S E R V I C E N O T E

8751A Network Analyzer

Modification to prevent the 8751A from a hanging-up when it is initializing a microfloppy disk.

DATE: 24 January 1992

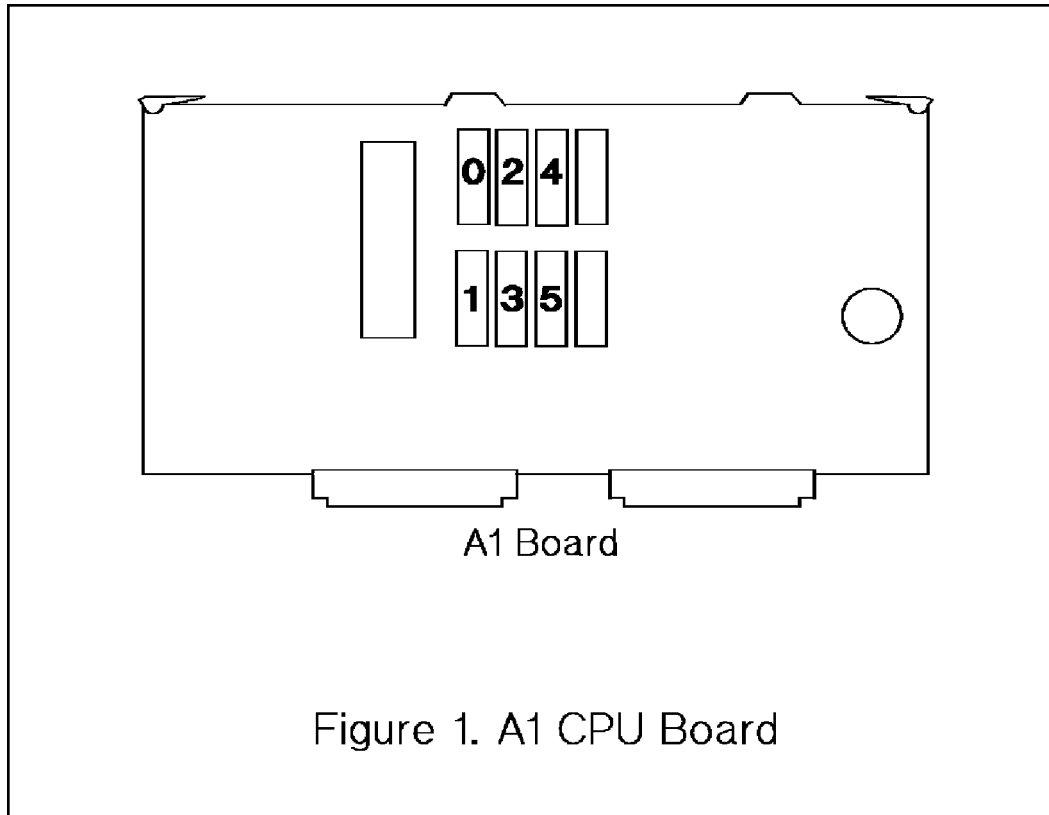
When a microfloppy disk is being initialized for the first time on the 8751A's disk drive, initializing may cause the 8751A to hang up. This symptom will occur ONLY on the 8751A Rev.4.00. And it will not occur on a microfloppy disk which has already been initialized once.

1. Turn the 8751A ON.
2. Press [SYSTEM], 'SERVICE MENU', and 'FIRMWARE REVISION'. Confirm that the firmware revision is 4.00. (If it is NOT Rev.4.00, the problem is having caused for another reason).
3. Turn the 8751A OFF.
4. Remove the top cover and the shield plate.
5. Remove the A1 board.
6. Remove the programmed ROMs from the A1 board and install new ROMs as follows:

Reference Designator	Part Number	Description
0 (A1U43)	08751-85801	ROM (Rev.4.01)
1 (A1U44)	08751-85802	ROM (Rev.4.01)
2 (A1U45)	08751-85803	ROM (Rev.4.01)
3 (A1U46)	08751-85804	ROM (Rev.4.01)

Reference Designator	Part Number	Description
0 (A1U43)	08751-85511	ROM (Rev.4.01)
1 (A1U44)	08751-85512	ROM (Rev.4.01)
2 (A1U45)	08751-85513	ROM (Rev.4.01)
3 (A1U46)	08751-85514	ROM (Rev.4.01)
4 (A1U47)	08751-85515	ROM (Rev.4.01)
5 (A1U48)	08751-85516	ROM (Rev.4.01)

7. Reinstall the A1 board.
8. Turn the 8751A ON.
9. Press [SYSTEM], 'SERVICE MENU', and 'FIRMWARE REVISION'. Confirm that the firmware revision is 4.01.
10. Turn the 8751A OFF.
11. Reinstall the shield plate and the top cover.
